**FEASIBILITY STUDY
FOR OPERABLE UNIT - 3**

**VINYL CHLORIDE SUBPLUME IN THE VICINITY OF MW-52
HICKSVILLE, NEW YORK**

UNITED STATES ENVIRONMENTAL PROTECTION AGENCY

The OU-3 Feasibility Study for Operable Unit-3 for the Hooker Ruco Site has been approved with the following changes:

figure 3.1
VCM SUBPLUME - PLAN VIEW
OU-3 FEASIBILITY STUDY
Hicksville, New York

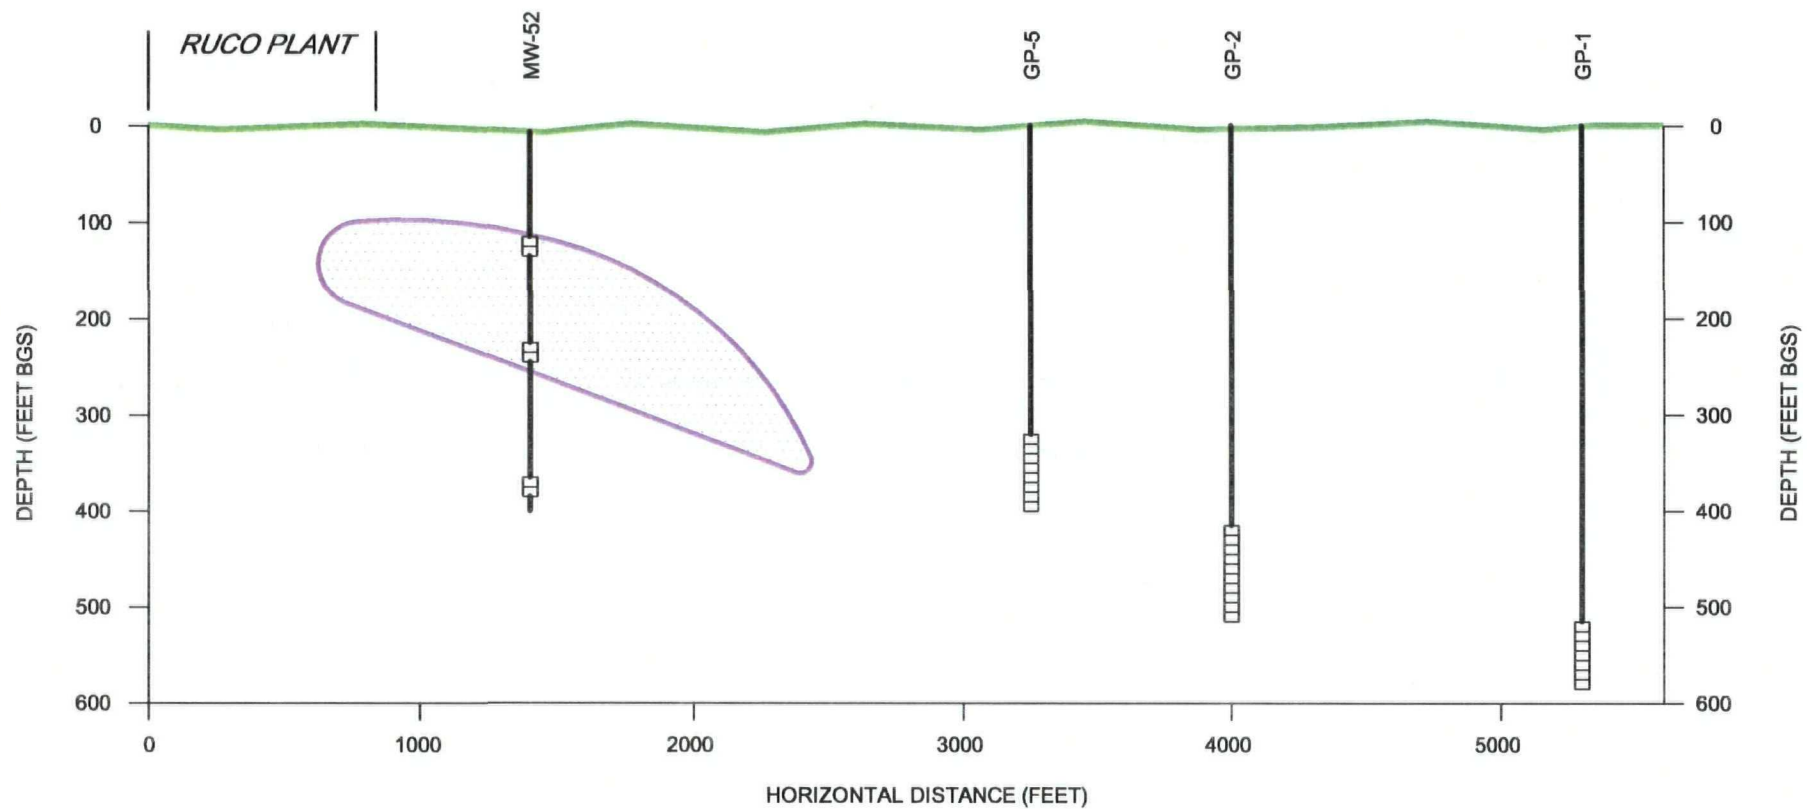
1 Figures 3.1 and 3.2:

Figure 3.1, 4.1, 4.3, 4.5, 4.6, 4.7 and 4.8 of the FS have not accurately depicted TCE/PCE plume.
